Drawing Amendments

Applic. No. 10/694,600
Amdt. dated March 28, 2005
Reply to Office action of December 28, 2004

Fig. 1

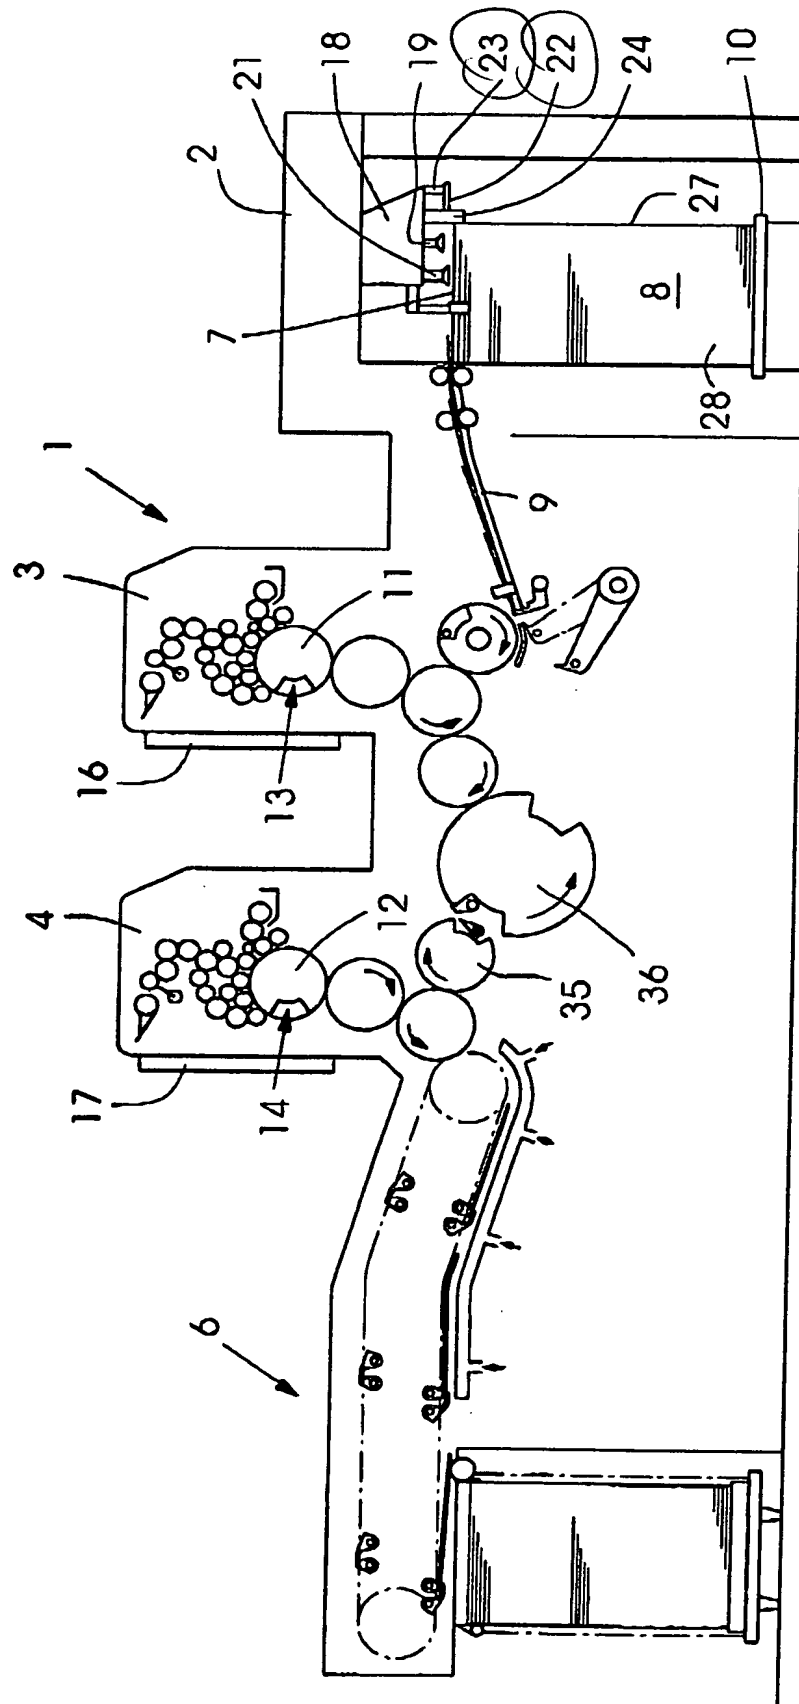
The Examiner stated that the reference characters "22" and "23" are used to designate the same part. The drawings have been changed as noted above so as to facilitate prosecution of the application. Therefore, the objection to the drawings by the Examiner is believed to have been overcome.

The Examiner stated that "blowing devices 22" should be --blowing device 22-- and "sensing elements 23" should be --sensing element 23--. Applicants respectfully disagree with the Examiner. Fig. 1 is a two dimensional diagrammatic view of a printing press. The leaders indicating these items point to the side of the elements and sufficiently support the fact that there is a plurality of the items. This does not require

This sheet which includes Fig. 1, replaces the original sheet including Fig. 1. In Fig. 1, previously references characters "22" and "23" were changed so as not to designate the same part.

Please approve the drawing changes that are marked in red on the accompanying "Annotated Sheet Showing Changes" of Fig. 1. A formal "Replacement Sheet" of amended Fig. 1 is also enclosed.

any further clarification in the specification. Therefore, the specification has not been amended to overcome the objection by the Examiner.
